**TOWN OF SHADY SHORES
PLANNING AND ZONING COMMISSION
MARCH 16, 2016, 7:00 PM
SHADY SHORES COMMUNITY CENTER
101 S. SHADY SHORES ROAD
SHADY SHORES ROAD, TX 76208**

Consider and take action relative to an application for a replat made by David Steinbrunner for a replat of Lots 155 and 156 into the proposed 155S in Hidden Valley Air Park.

ACTION REQUESTED: Consider and take action relative to a request for replat made by David Steinbrunner.

MINOR REPLAT
HIDDEN VALLEY AIRPARK, PHASE V
LOT 155S-R
 being a replat of Lots 155S and 156S of
 Hidden Valley Airpark, Phase V, recorded in
 Cabinet Y, Page 673, Plat Records, Denton County, Texas
 2.251 acres out of the
 W. Durham Survey, Abst. No. 330
 Town of Shady Shores, Denton County, Texas

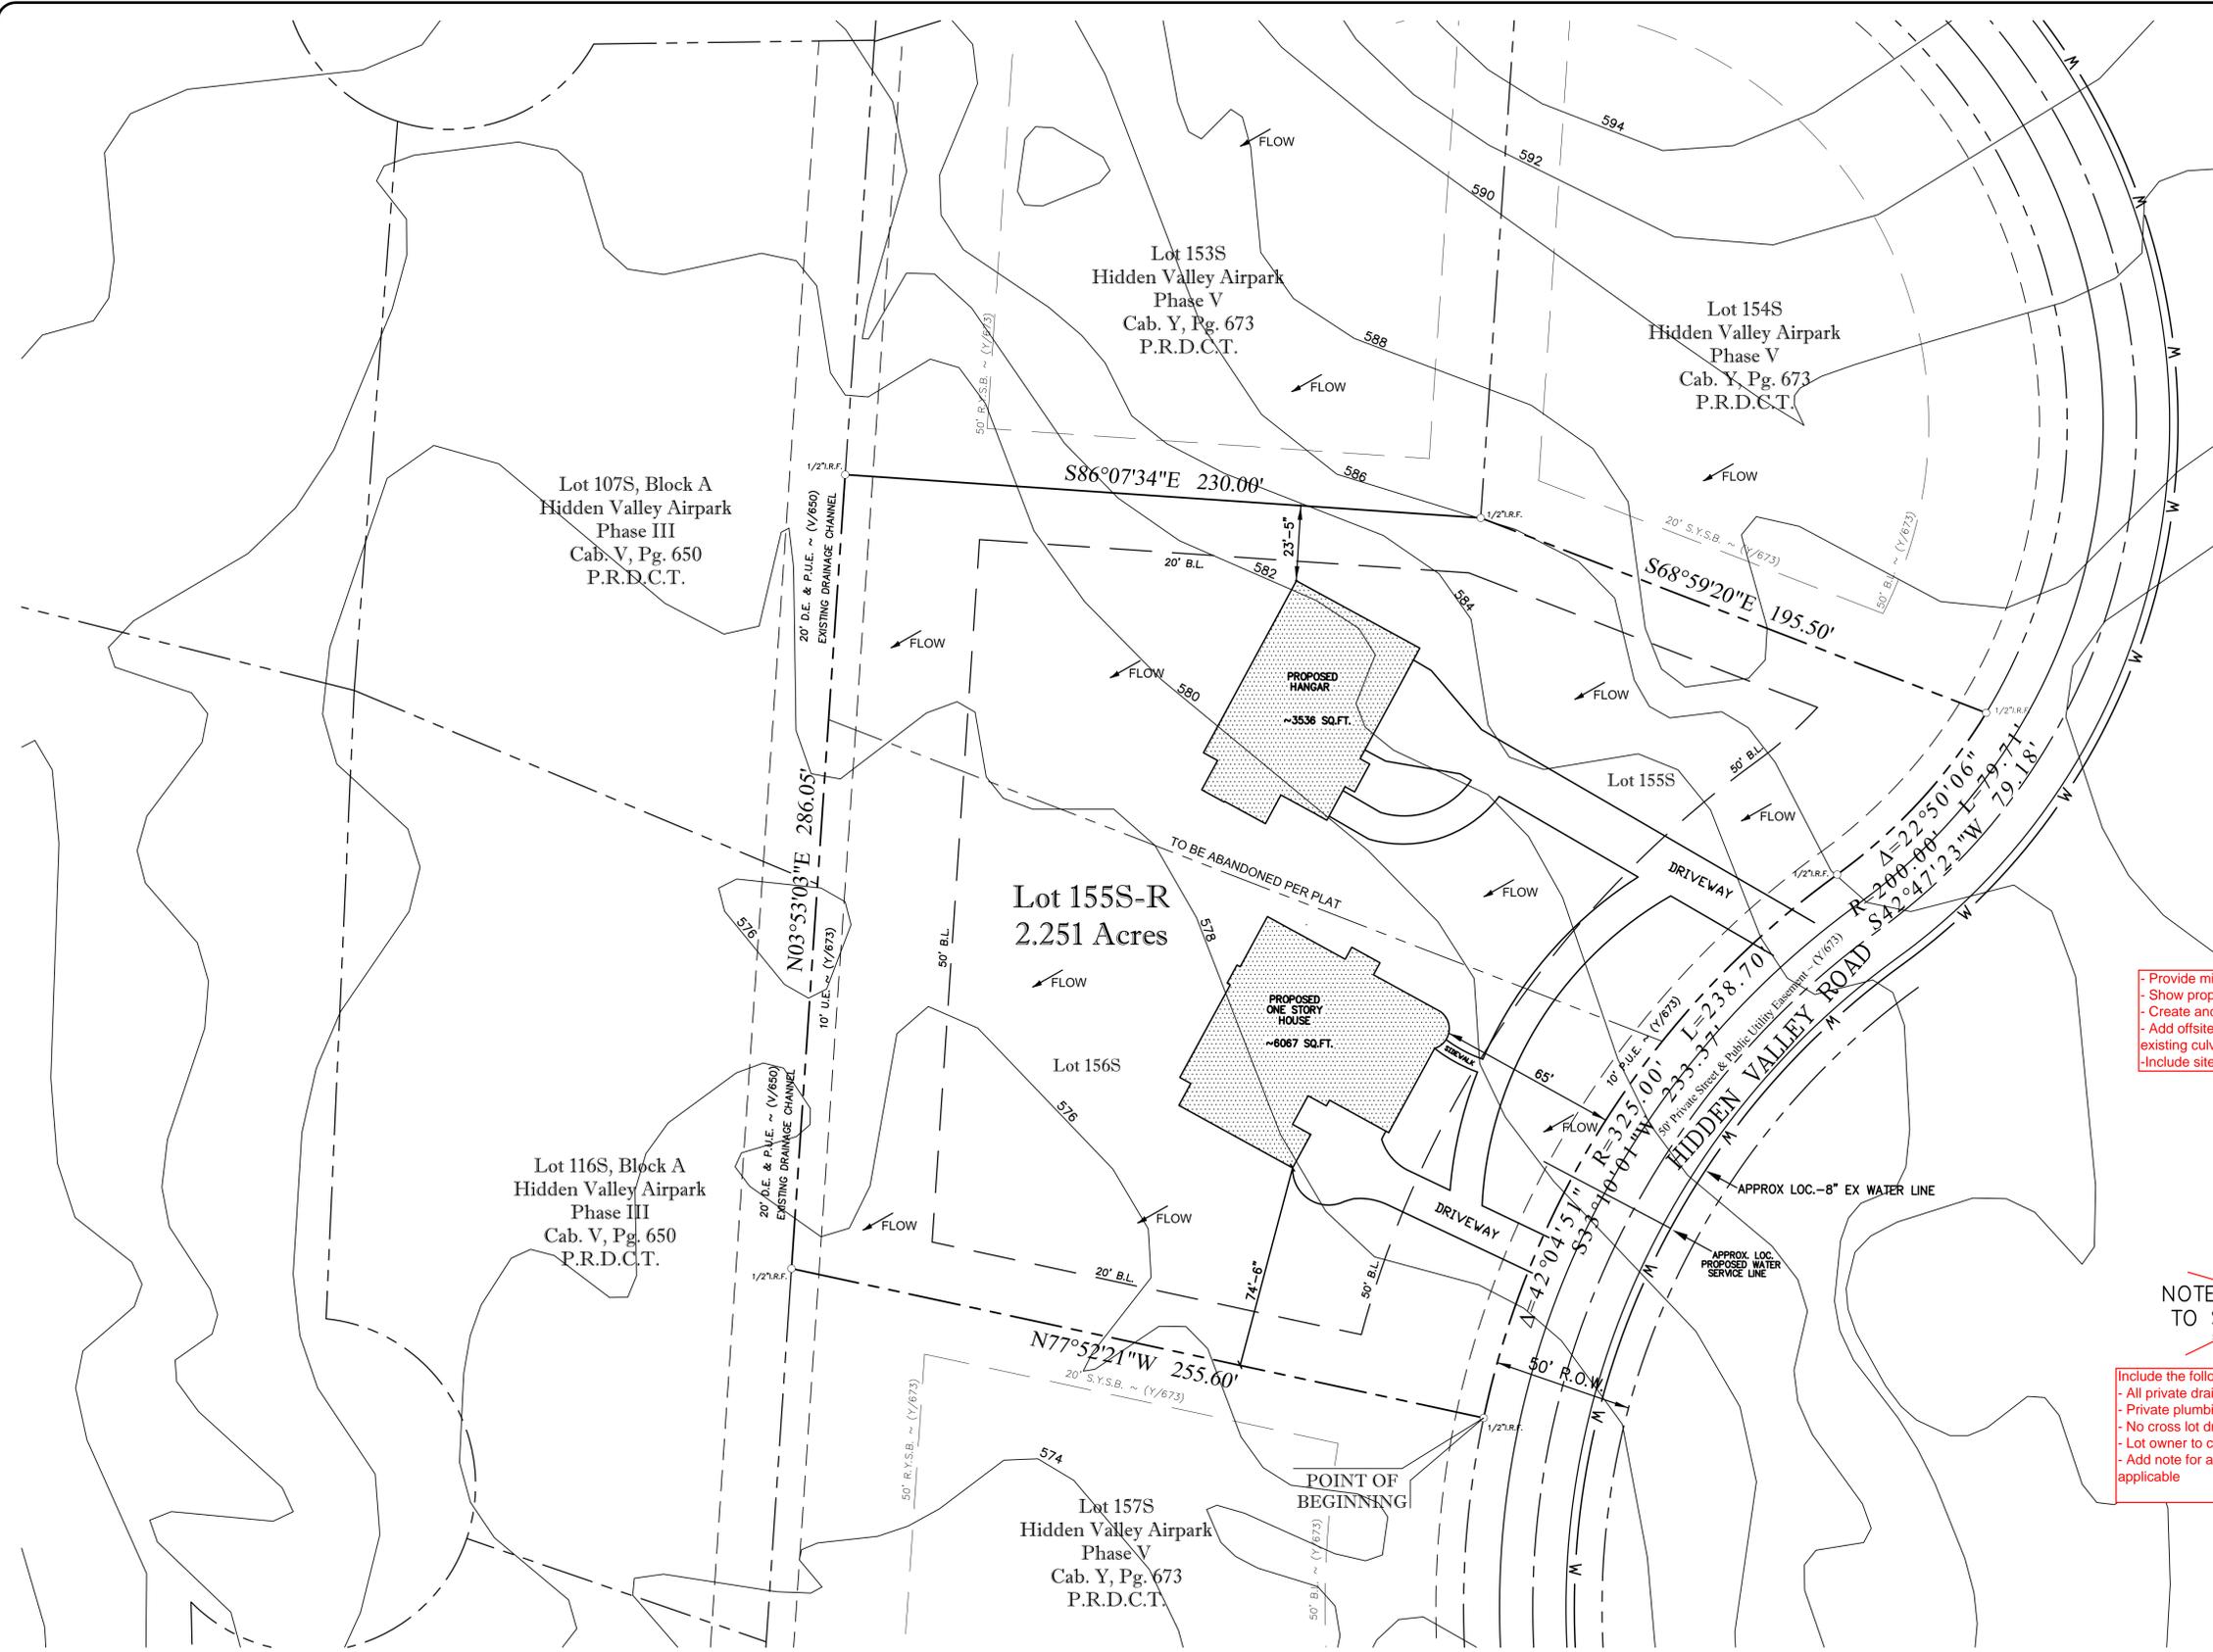
Include the following notes:
 - All private drainage easements are to be maintained by property owners
 - Private plumbing will not be allowed across property lines
 - No cross lot drainage will be allowed between Lots 155S-R and 157S
 - Lot owner to connect to sewage collection system when made available
 - Add note for and show site bench mark and reference to NAVD88 or as applicable

CONCEPT PLAN
HIDDEN VALLEY
LOT 155S-R

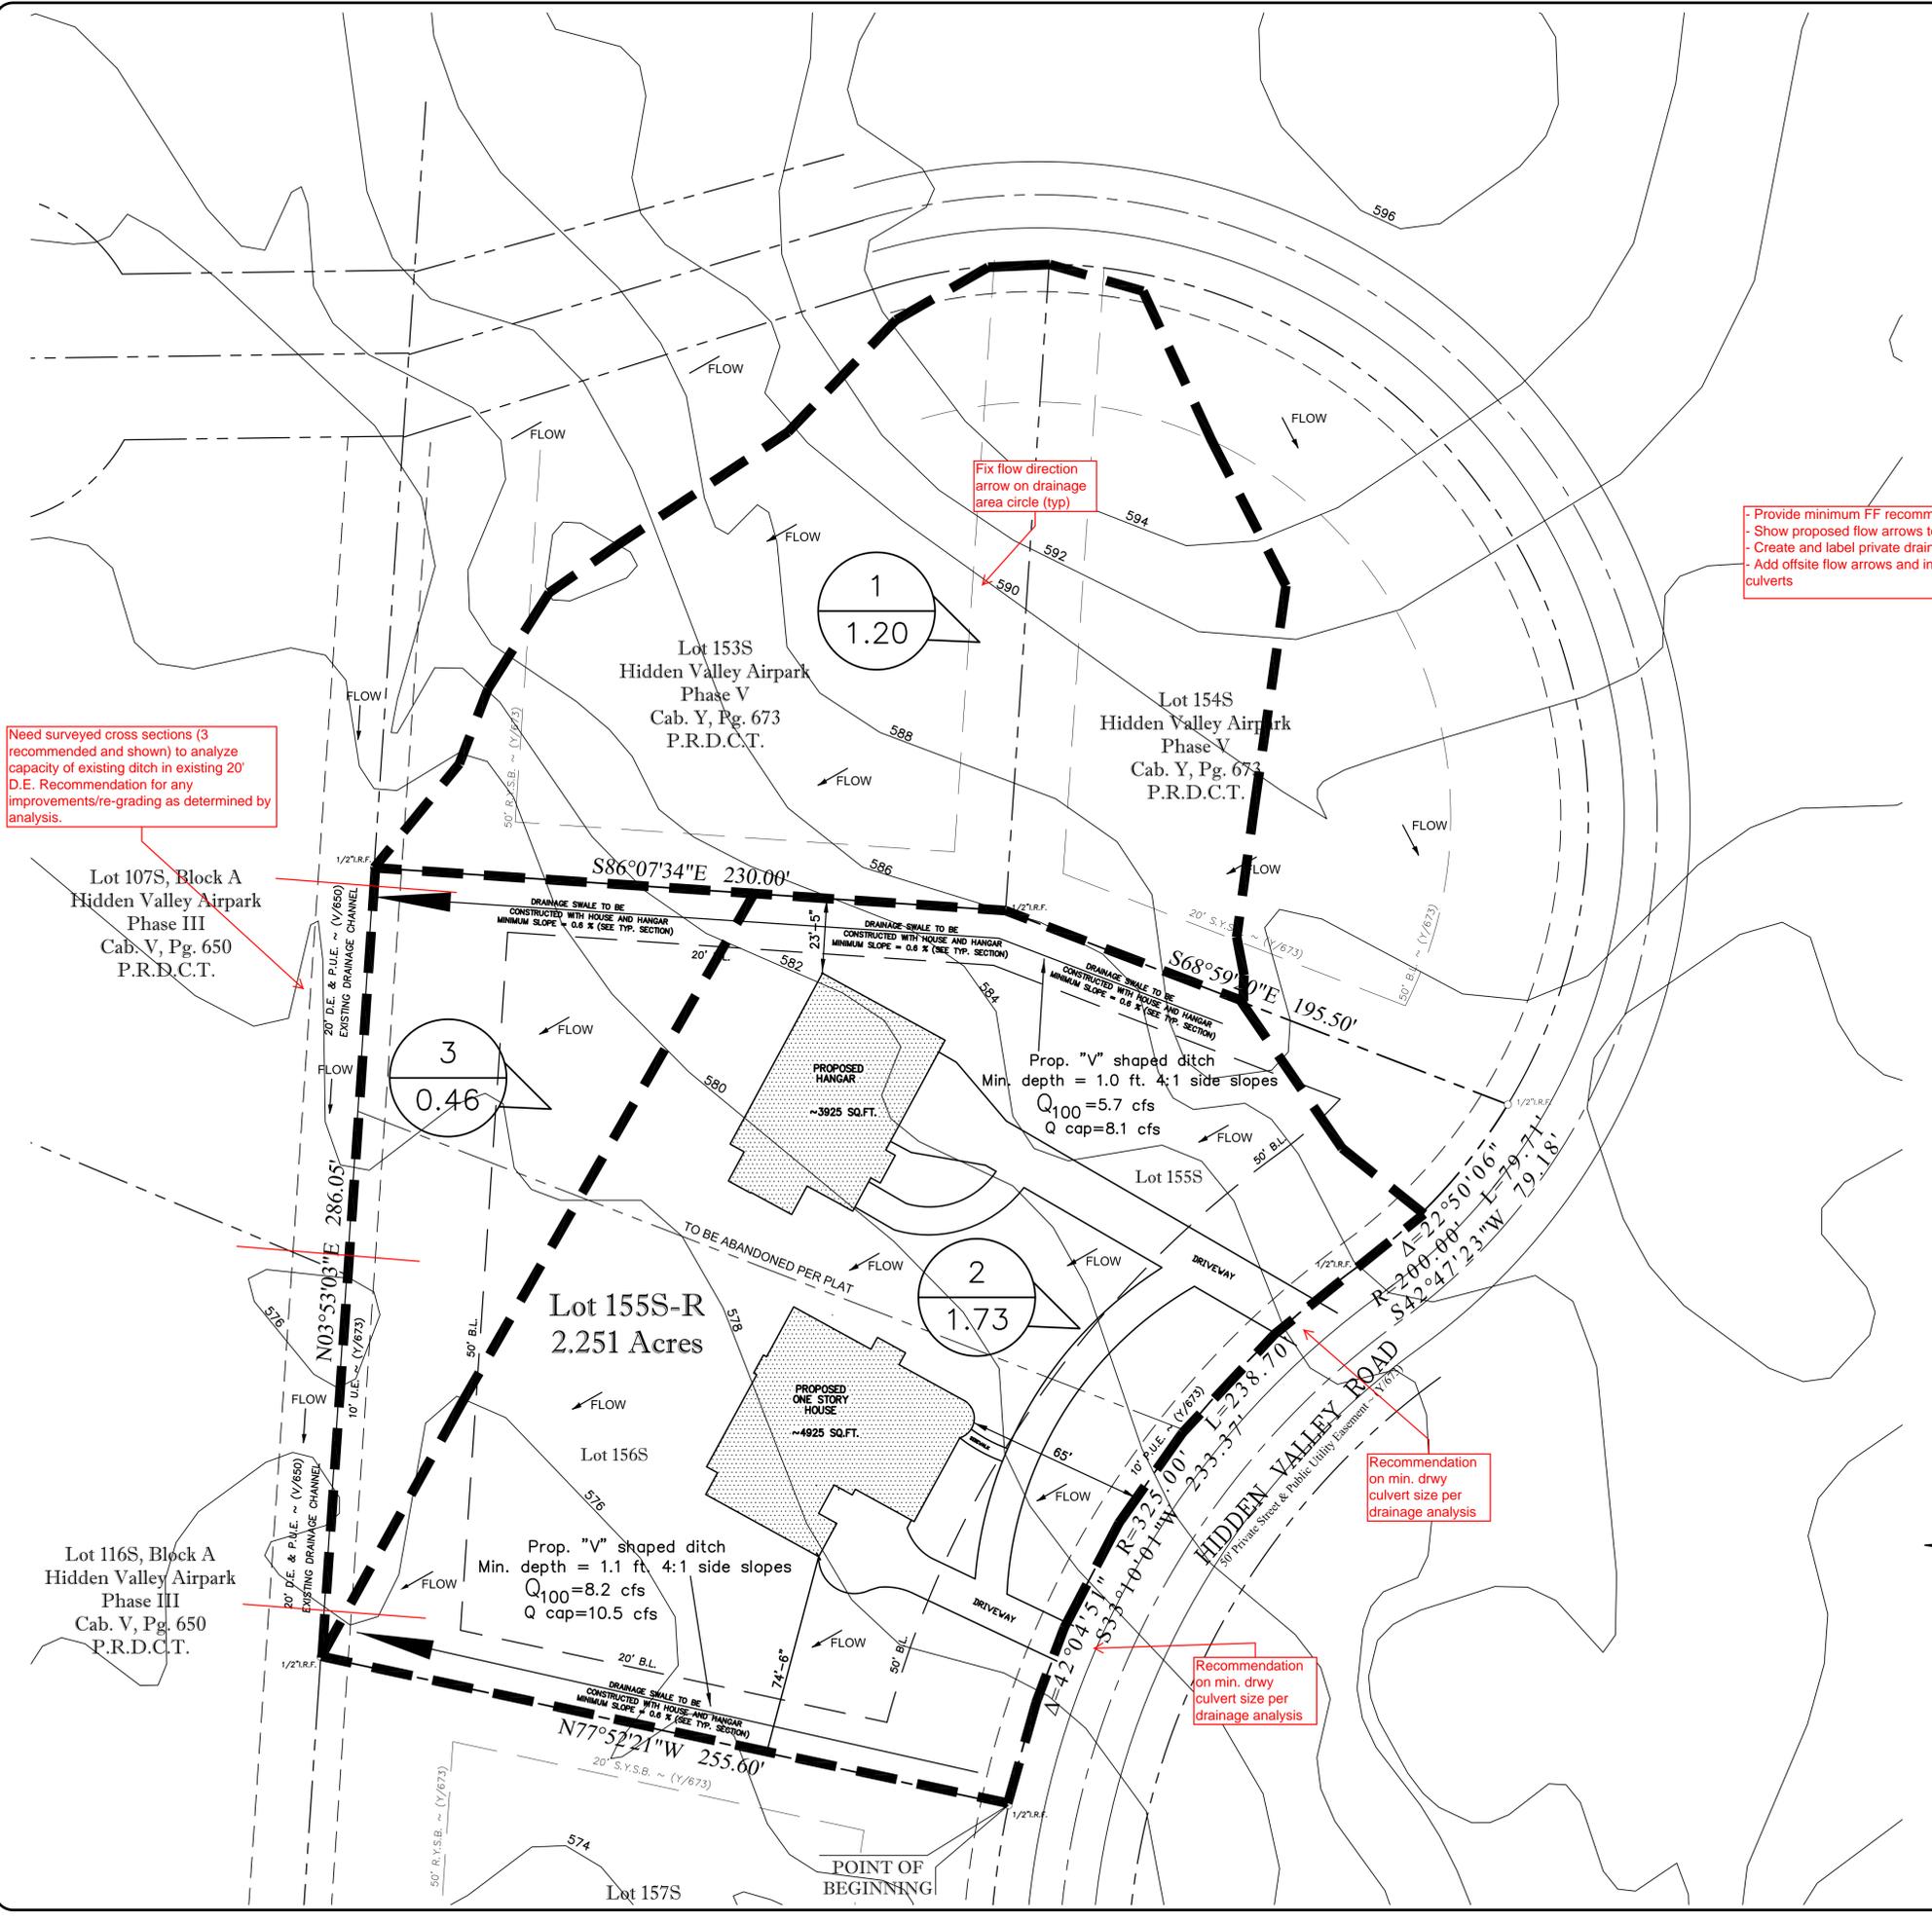
- LEGEND**
- Provide minimum FF recommendation for both buildings
 - Show proposed flow arrows to demonstrate proposed grading
 - Create and label private drainage easements (15' min. width)
 - Add offsite flow arrows and indicate roadside ditches and existing culverts
 - Include site benchmark (NAVD88)

- Include the following notes:
- All private drainage easements are to be maintained by property owners
 - Private plumbing will not be allowed across property lines
 - No cross lot drainage will be allowed between Lots 155S-R and 157S
 - Lot owner to connect to sewage collection system when made available
 - Add note for and show site bench mark and reference to NAVD88 or as applicable
